HISTORIC AND DESIGN REVIEW COMMISSION

HDRC CASE NO: 2024-286
ADDRESS: 401 KING WILLIAM
LEGAL DESCRIPTION: NCB 745 BLK LOT SE IRR 279.44 FT OF 1, 2 & 3
ZONING: R-4 IDZ S H HE RIO-4 AHOD
CITY COUNCIL DIST.: 1
DISTRICT: King William Historic District
APPLICANT: Samuel White/Michael G. Imber Architects
OWNER: Jane Lewis/NATIONAL TRUST FOR HISTORIC PRESERVATION IN THE US
TYPE OF WORK: Construction of an accessory structure
APPLICATION RECEIVED: August 01, 2024
60-DAY REVIEW: September 30, 2024
CASE MANAGER: Edward Hall

The applicant is requesting a Certificate of Appropriateness for approval to construct an accessory structure to function as a visitors' center on the property at 401 King William Street, commonly known as Villa Finale. The proposed new construction will feature one story in height and an overall footprint of 1,893 square feet.

PROPOSED VISITORS' CENTER

PROPOSED SITE PLAN

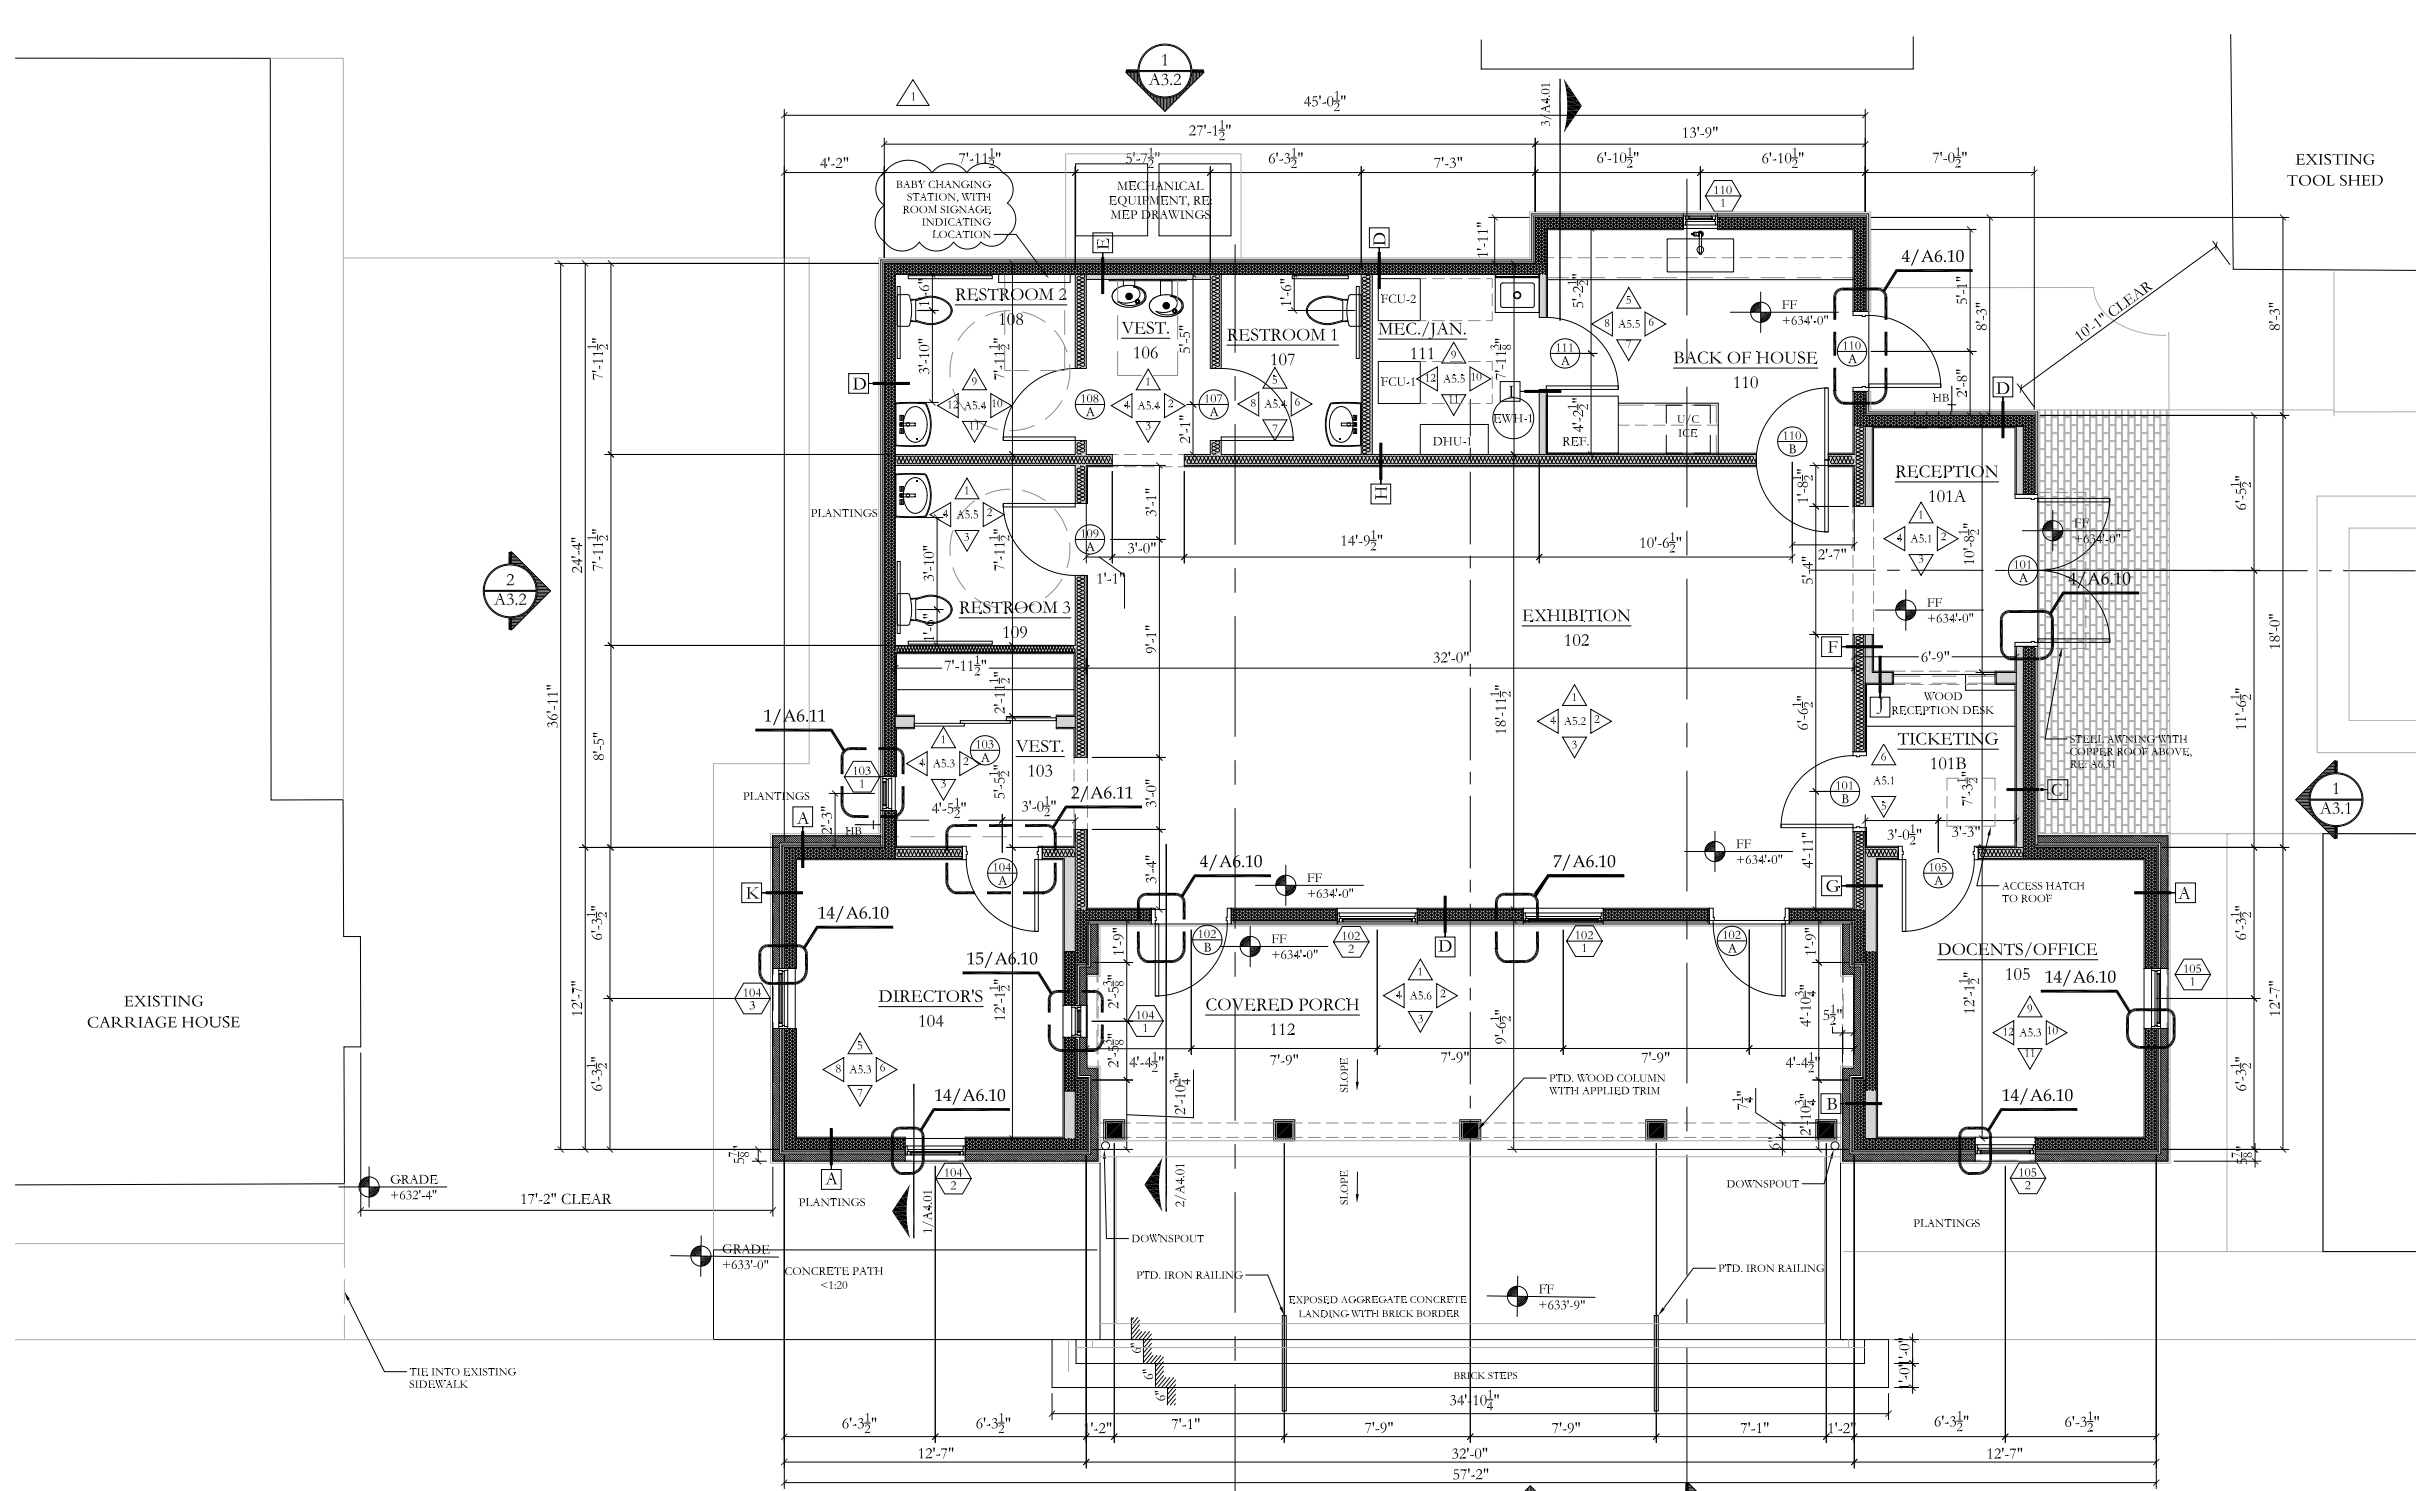
- f. **ORIENTATION & SETBACK** – Accessory structures on this block of King William Street are predominantly located at the rear of sites. The Guidelines for New Construction 5.B. notes that the predominant accessory structure orientation and historic setback patterns of the block should be followed. The applicant has proposed to locate this structure towards the rear of the lot, consistent with the locations of existing accessory structures on site. Staff finds the proposed orientation and setback to be appropriate and consistent with the UDC.

- i. SITE PAVING – Around the proposed new construction the applicant has proposed site paving in various locations. The applicant has proposed concrete sidewalks around the new construction and decorative paving with inlaid borders. Staff finds the proposed paving to be appropriate.

- j. LANDSCAPING – The applicant has provided both a landscaping and tree preservation plan noting the preservation of existing trees and the location of small planting areas. Staff finds the proposed landscaping to be appropriate.

PROPOSED SOUTH ELEVATION

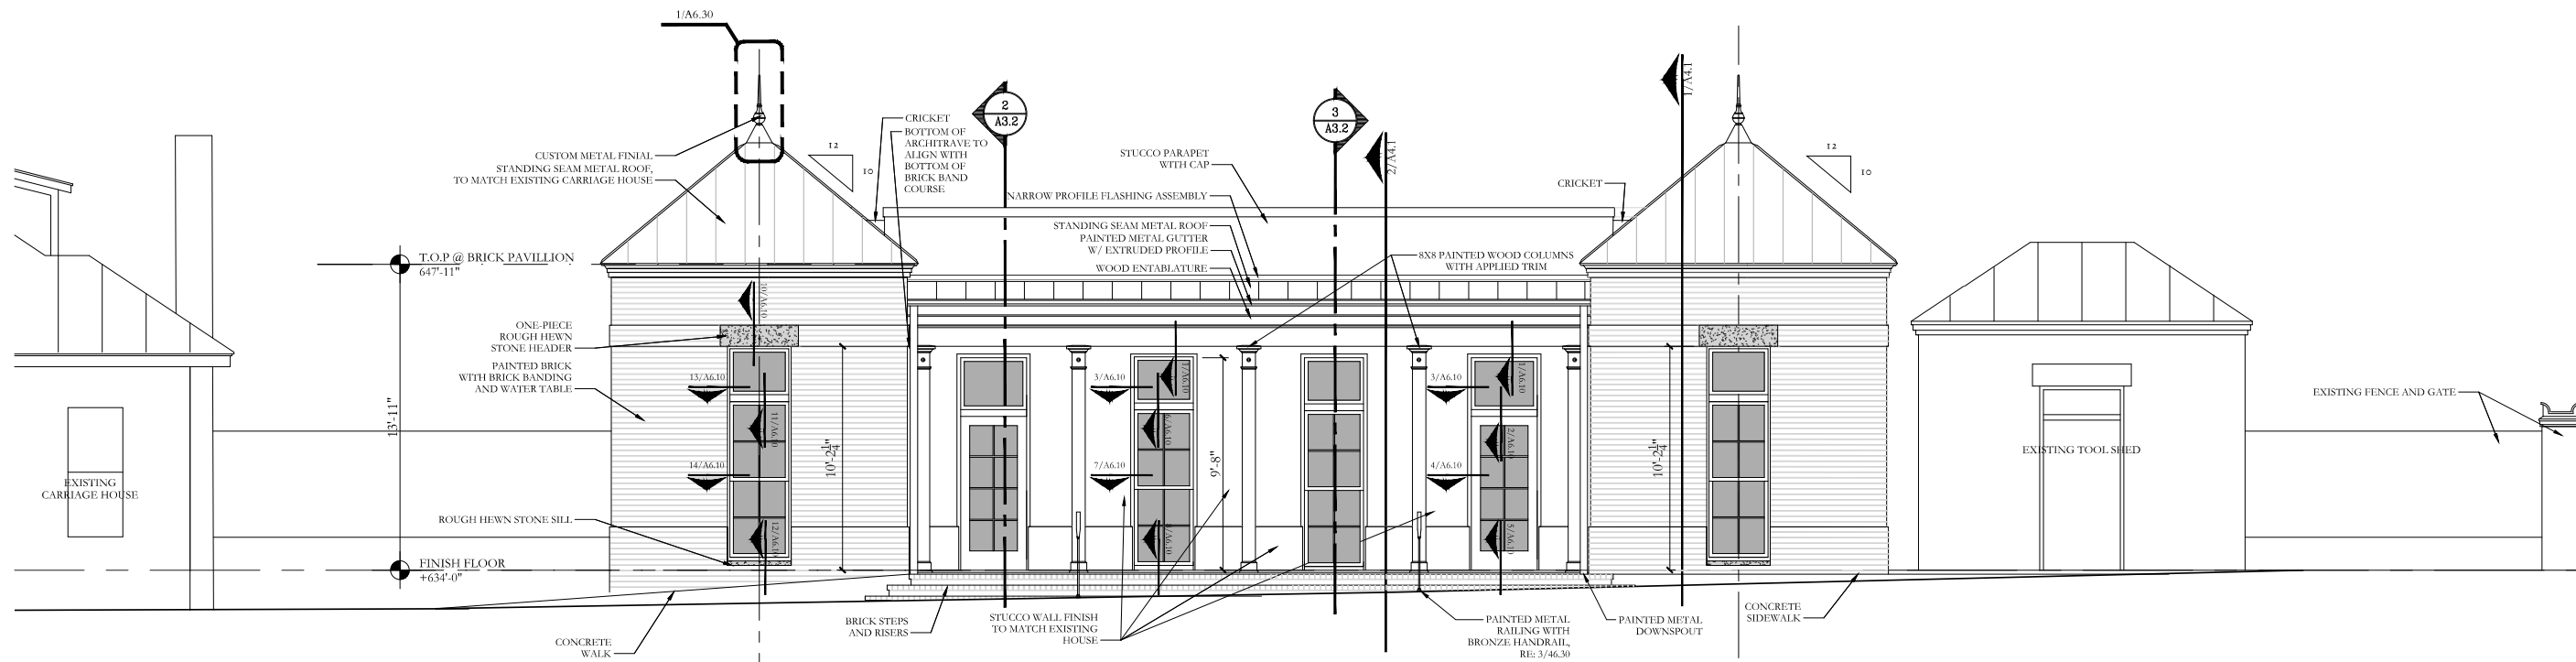
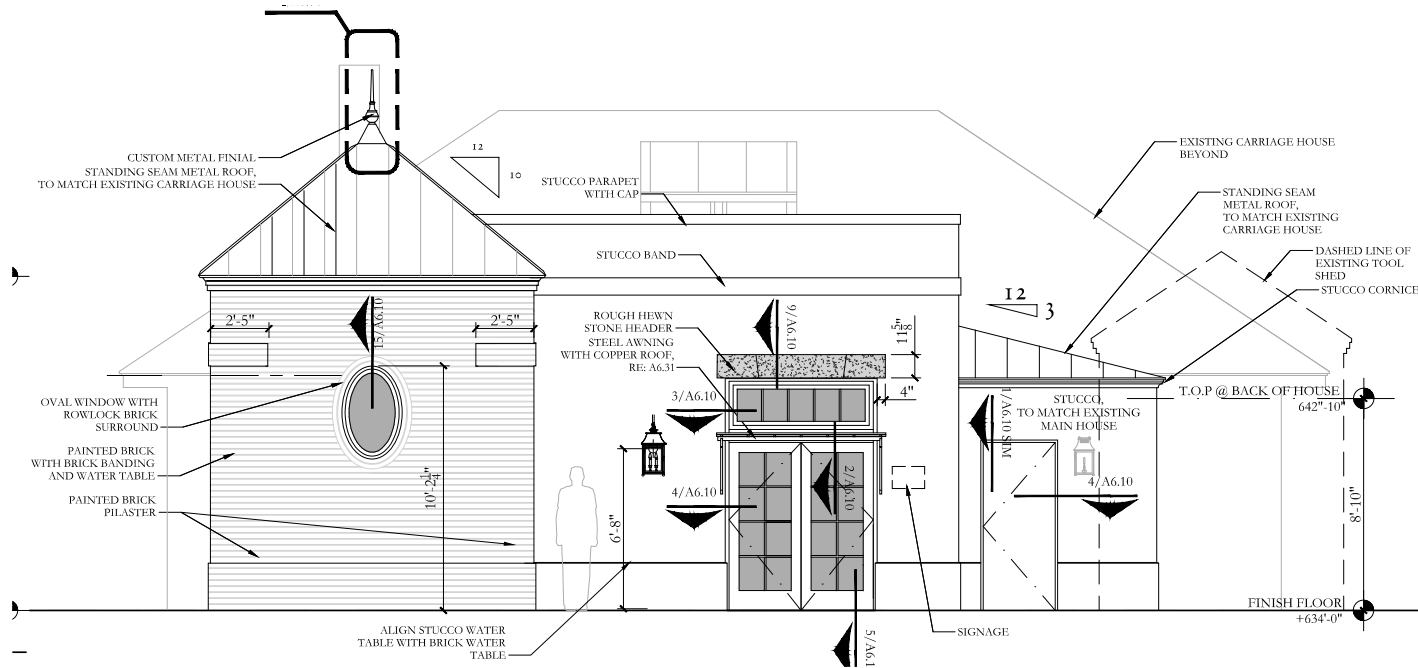
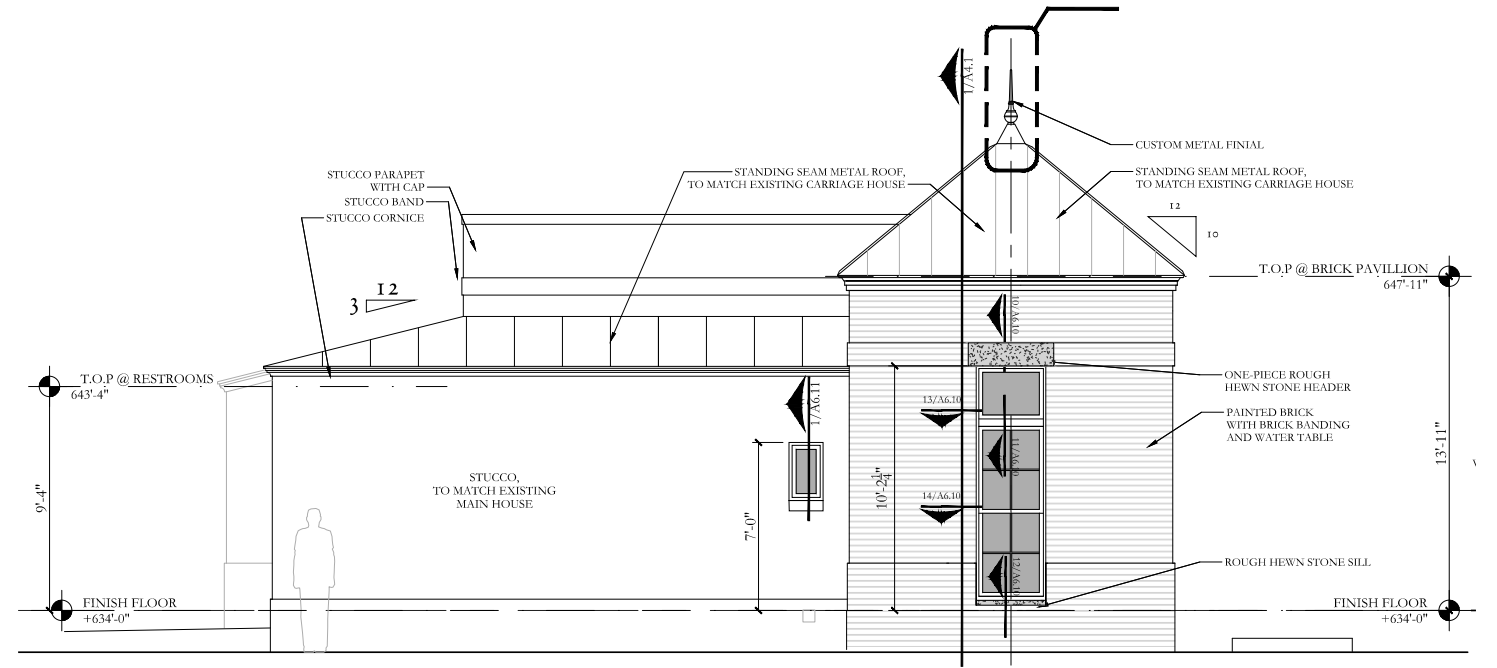
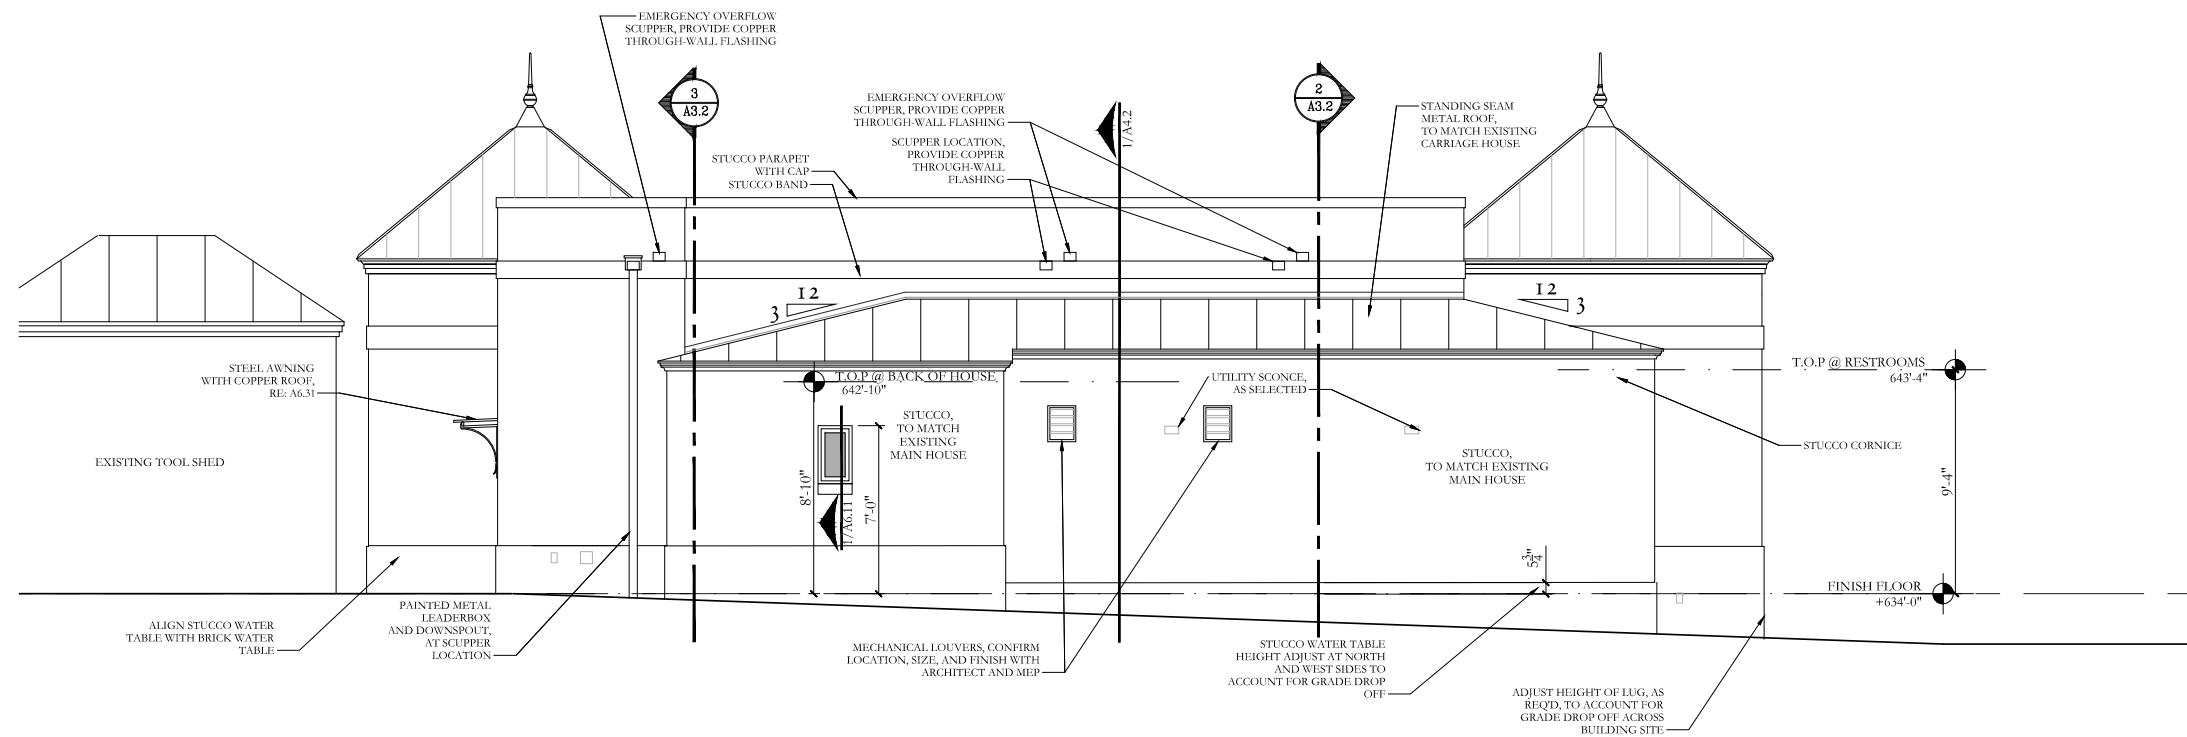
- e. **MASSING & FORM** – The applicant has submitted application documents noting the overall height and massing of the proposed new construction. The applicant has proposed for the height and massing to generally be subordinate to that of the existing accessory structure, the carriage house. The applicant has proposed an overall height and massing that staff finds to be consistent with the Guidelines and historic examples found within the immediate vicinity.

- g. **CHARACTER** – The Guidelines for New Construction 5.A. notes that new accessory structures should relate to the primary historic structure in regards to their materials and window and door openings. The applicant has proposed a design that features architectural elements that reference those found historically on site.

Additionally, the applicant has proposed materials that relate to those found on the primary historic structure on site, including cut stone, painted brick and stucco. Staff finds the proposed character of the proposed new construction to be appropriate and consistent with the Guidelines. Staff finds that the proposed stucco should feature a texture and profile that is consistent with that found historically on site.

PALETTE OF MATERIALS

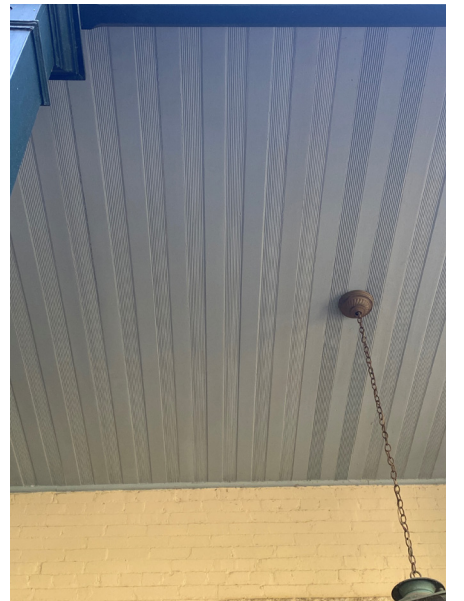
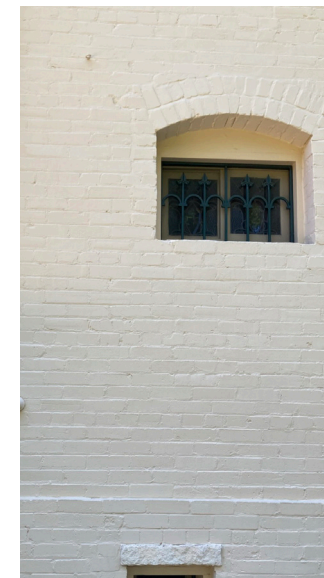
- h. WINDOW MATERIALS – Per the construction documents, the applicant has proposed aluminum clad wood windows. Additionally, the applicant has submitted construction documents noting window profiles, installation depths and sill profiles. Generally, staff finds the proposed windows to be appropriate; however, staff finds that all muntins should be applied to the exterior of windowpanes. Faux divided lites should not be used.

- i. That the proposed windows adhere to staff's standards for windows in new construction. Windows should feature true muntins and not feature internal muntins/faux divided lites.
- ii. ARCHAEOLOGY – The project shall comply with all federal, state, and local laws, rules, and regulations regarding archaeology, as applicable.
- iii. That the proposed stucco be detailed and feature a texture that is consistent with stucco found historically on site, as noted in finding g.
- iv. That the applicant coordinates with the San Antonio River Authority regarding landscaping and maintenance boundaries and storm water control measures.
